Re: 1600-Gallon Two-Chamber Combination Septic & Dosing Tank Approval

DOSING SEPTIC TANK
STEELE TANK #8
1600-GALLON CAPACITY
 STEELE'S SEPTIC TANK SERVICE
 LA GRANDE, OR 97850

Re: 1600-Gallon Two Compartment Tank
– Second Compartment
“Tee” Fitting

SHEET
A4

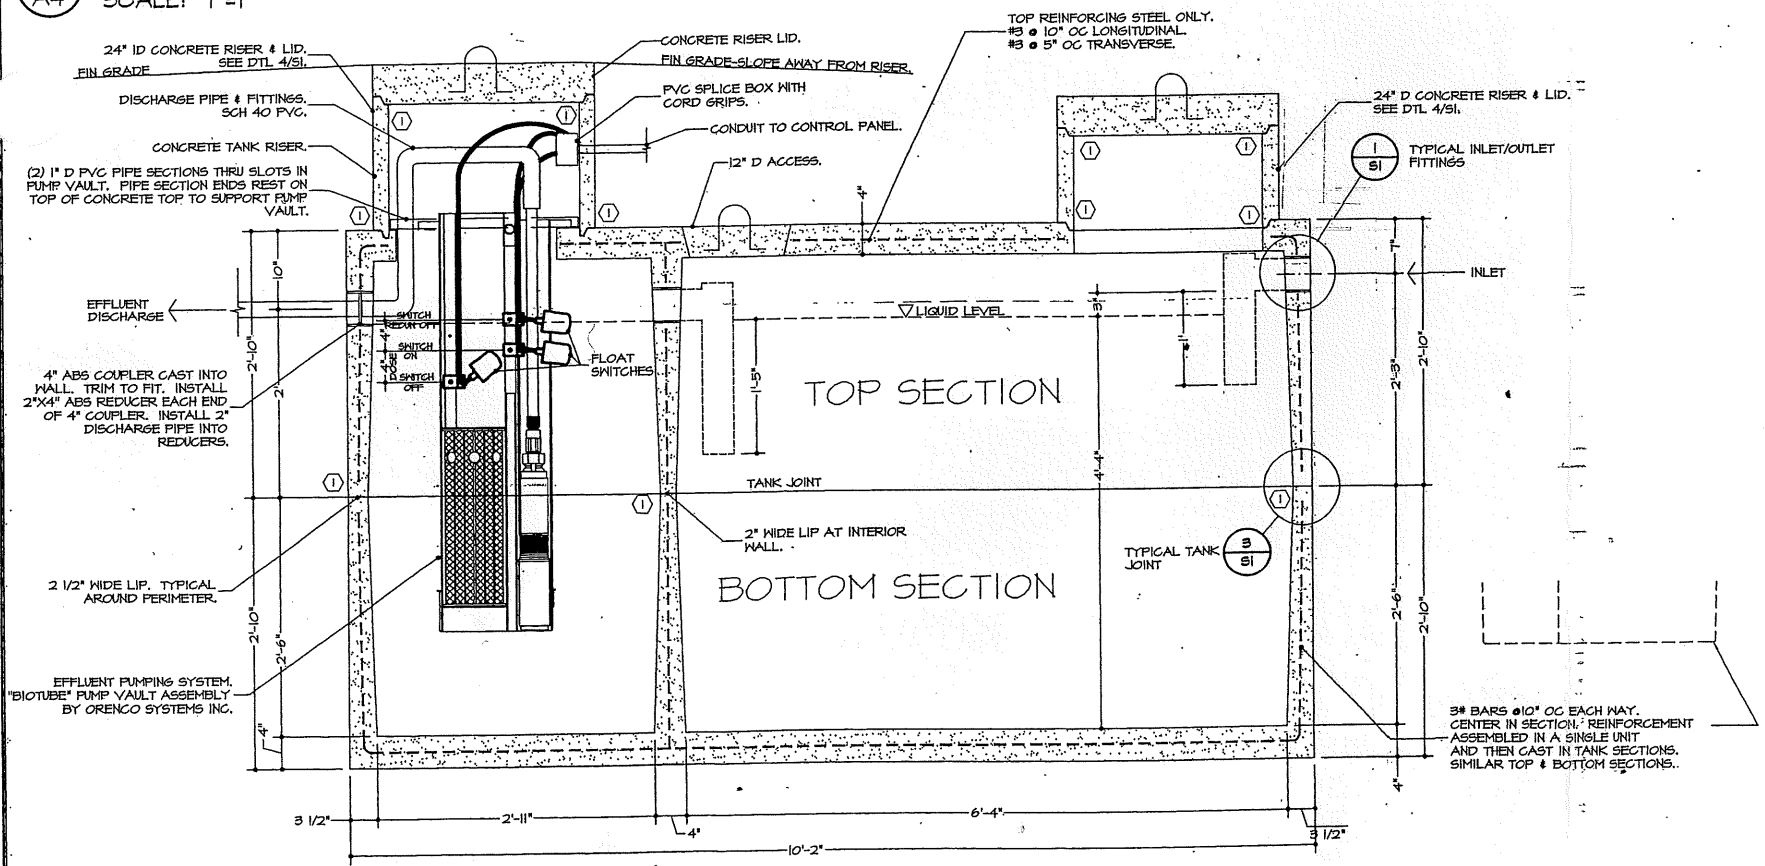
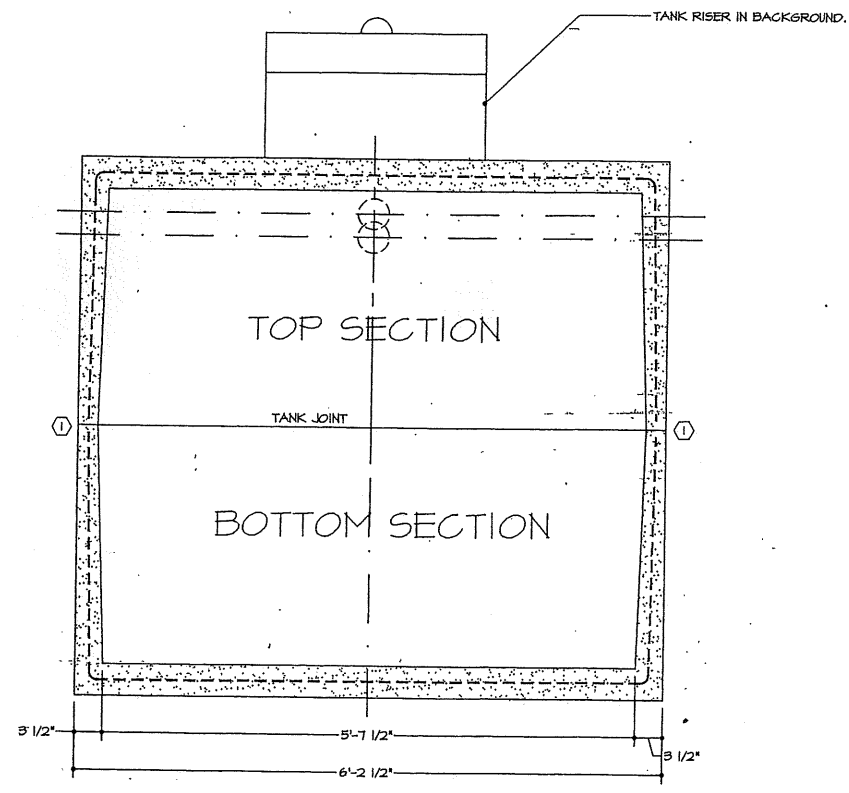
2. The records indicate that ConSeal is used as a concrete joint sealant. A concern is that should the lid from a riser be removed to service the tank, the riser would be no longer being watertight when the tank is placed back into service. Please specify in your installation manual that a new ConSeal bond needs to be established whenever the riser cover is removed during a service call.

3. The plans indicate concrete riser covers that appear heavier than 75 pounds. Your plan approval that you concurred with requires reducing all riser cover weights to less than 75 pounds for easy lifting and servicing.

As we discussed the other day on the phone, subsequent review of the August 2002 plans for this tank configuration revealed a minor oversight in design. This oversight involves the placement of a “tee” fitting on the inlet side of the second compartment.

Oregon Administrative Rule (OAR), 340-073-025 (8) for Septic Tanks states, “In tanks with more than one compartment, a 4 inch diameter (minimum) “tee” fitting shall be placed in each common compartment wall, using the same specifications as required for the outlet fitting. The invert of this “tee” fitting shall be at the same elevation as the outlet “tee”. Access ports and risers shall be provided for inspection and maintenance.

When the second compartment of this tank is to be used as a dosing or pump tank, the inlet “tee” fitting into the second compartment may need to be lengthened as specified in 340-073-0050 (6) for Dosing Tanks which states, “The inlet fitting shall extend below the lowest operating level of the pump or siphon.”

Therefore, we ask that all tanks manufactured after Monday, September 27, 2004 comply with the above mentioned modifications.
